# ADDENDUM No. 1

ITB No. 4617

## BARTON DRIVE WATER MAIN REPLACEMENT AND RESURFACING PROJECT

SHEET No. **26 OF 61**

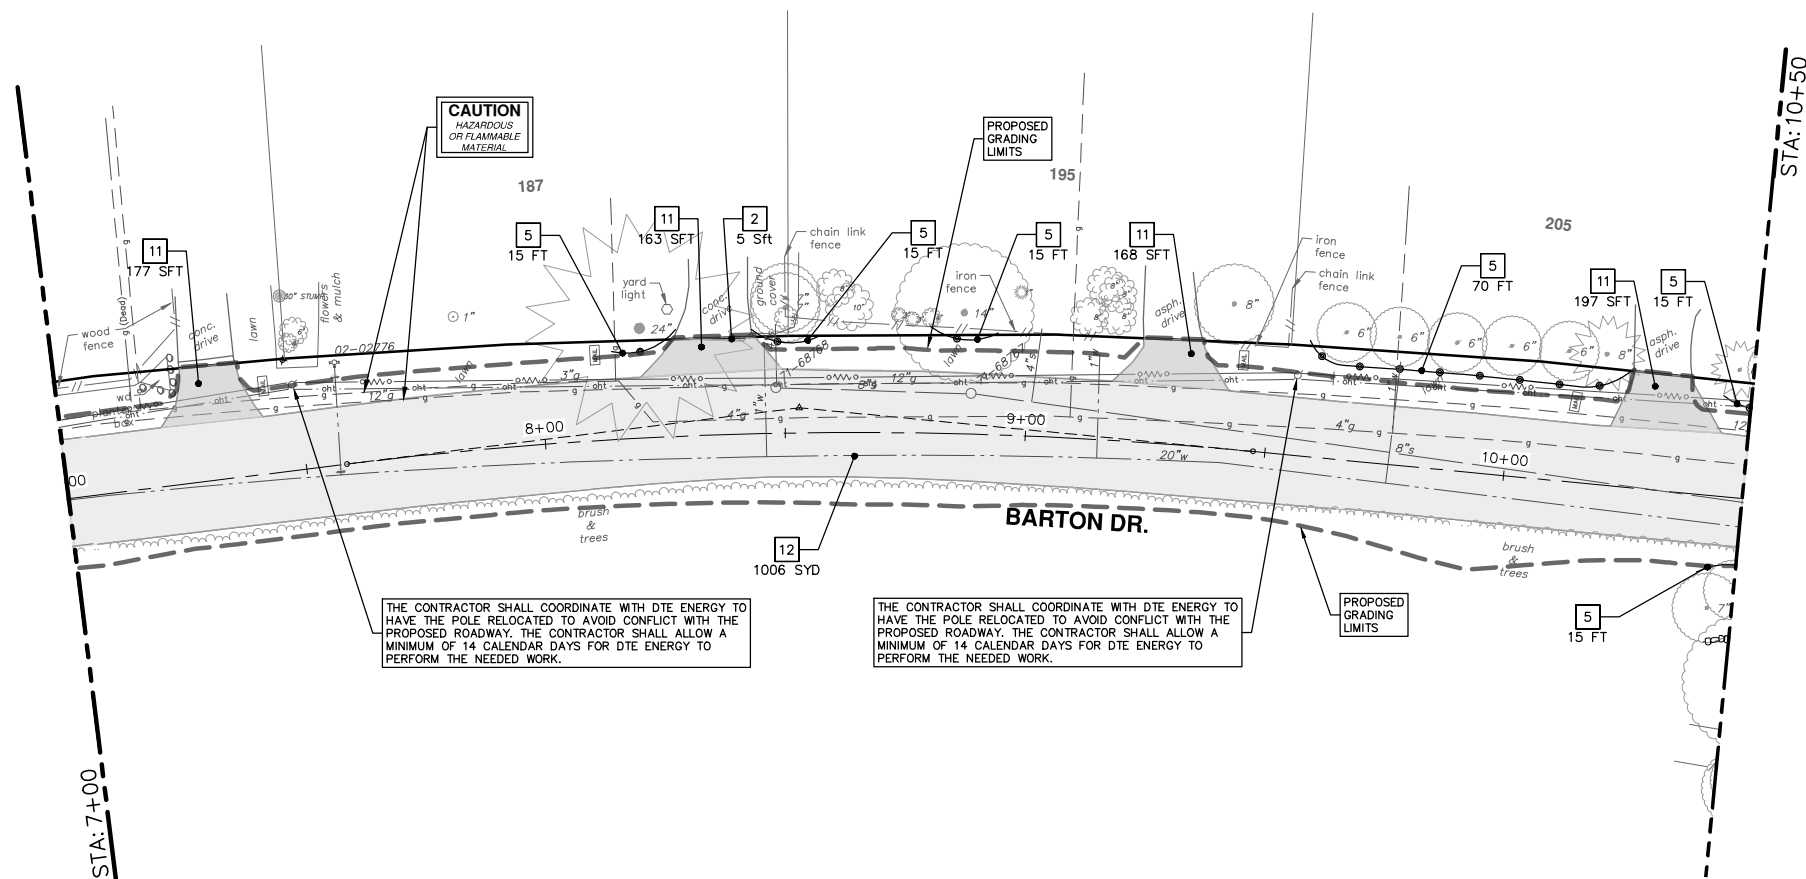
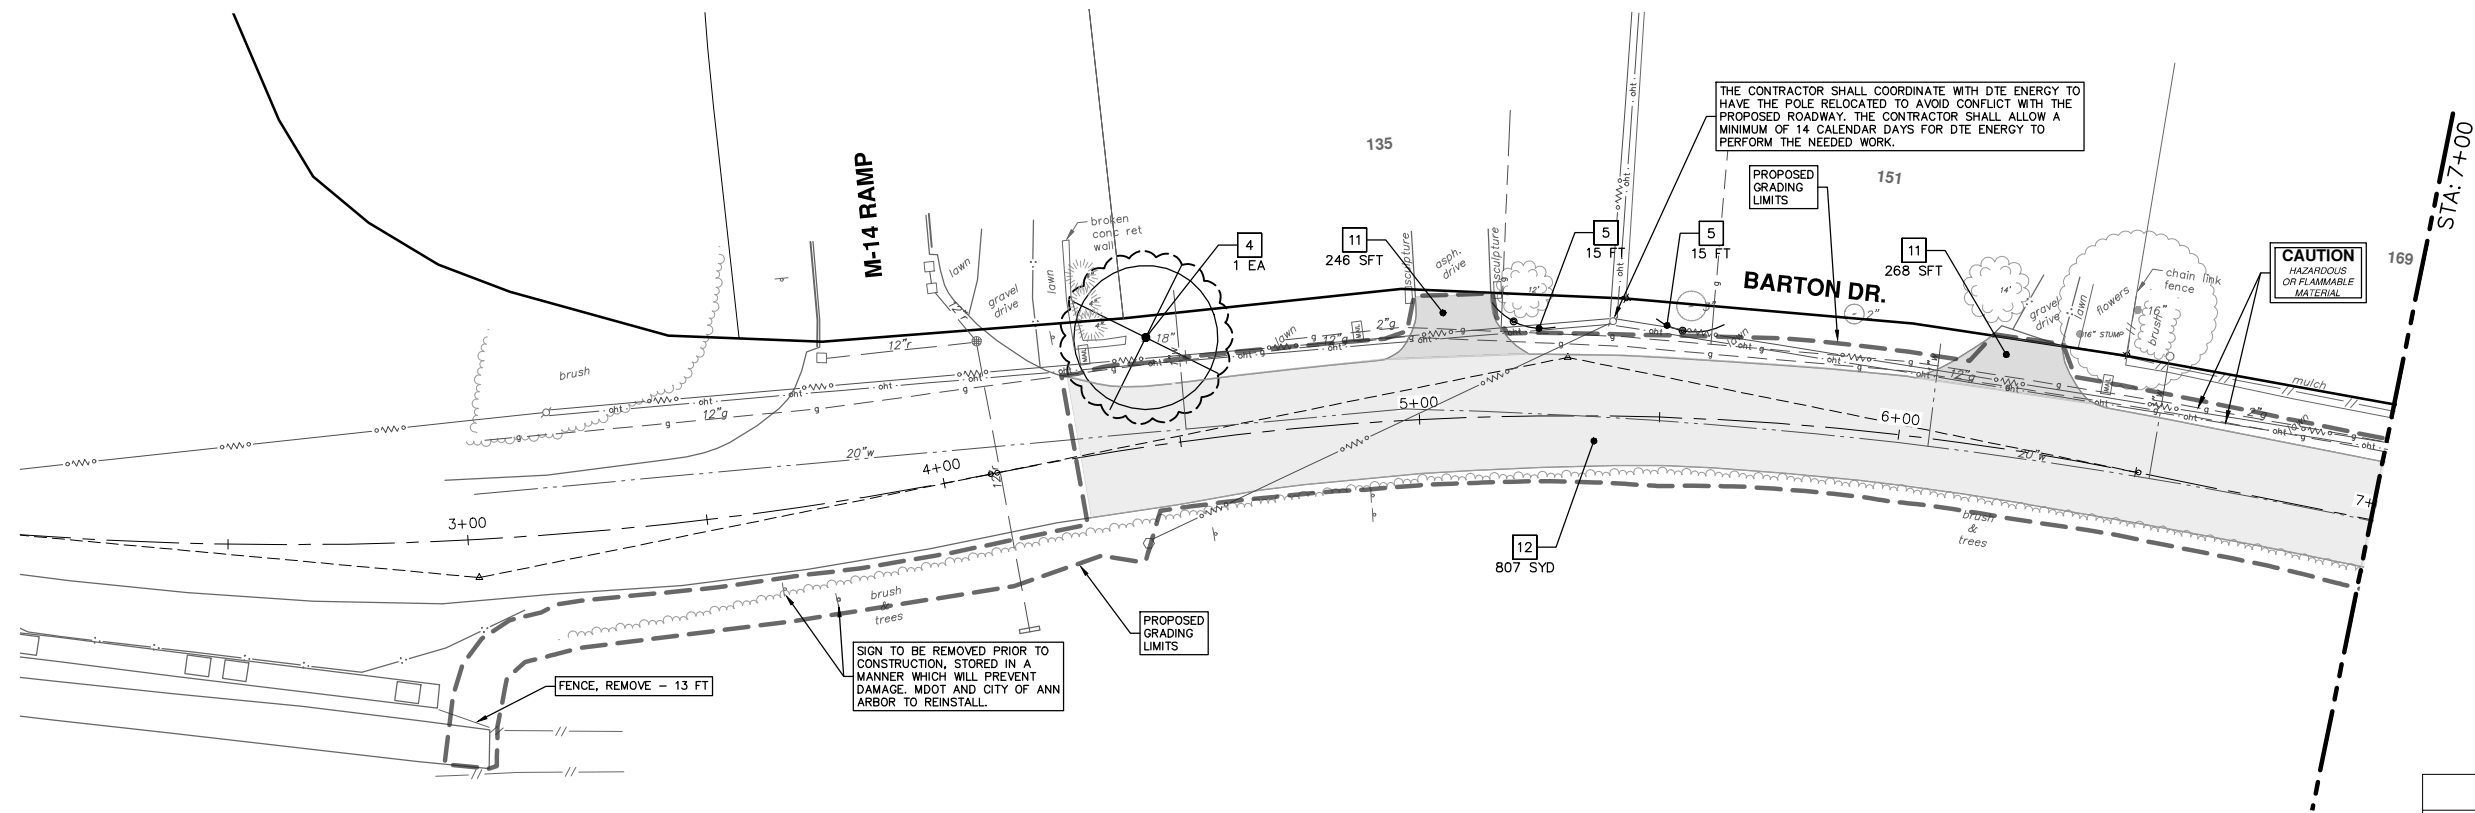
Plan Sheet 26              As provided in ITB No. 4617 Bid Document:  
Plan Sheet 26

As updated herein:  
Plan Sheet 26

*Comment: The intent with this change is to correct pay items call-out that were mislabeled to restore turf and excavate subbase for this item as provided in the ITB Document with the accurate plan sheet 26.*

Question 25: In front of house 815 on plan sheet 26 there is a callout for 2 ea. Item 9 "Sewer Remove" with leaders pointing to two trees. Can you please confirm the work to be done on the trees?

Question 26: I have a question regarding the HMA removal on this project. Item 213 – HMA Surface Remove has an estimated quantity of 4300 SF. I can't identify where this quantity is supposed to be assigned to? Is this quantity supposed to cover Phase 3 and the HMA driveways in Phase 4 removals? Also, is the intent to have the HMA removal of Barton Drive itself be included in Item 230 – Machine Grading? Or is the intent to have all the HMA removals in Item 213?

M14 ramps will be paid as Cold Milling HMA Surface. Sheet 26 has been updated to reflect this.

Answer 25: The City's Forestry Unit will remove necessary trees this spring, and those call-outs should have been "4" stump removals, see revised sheet 26, attached.

Answer 26: The item HMA Surface Remove is for the asphalt driveways and for reconfiguration of Barton/Starwick intersection (see attached Sheet 26). All pavement of Barton between EB M14 ramps and existing "shoulder" between EB M14 ramps and Brede Place will be paid with Machine Grading, Modified.

Answer 30: Correct, except HMA Surface Remove is also used at Barton/Starwick Intersection, see attached revised Sheet 26.
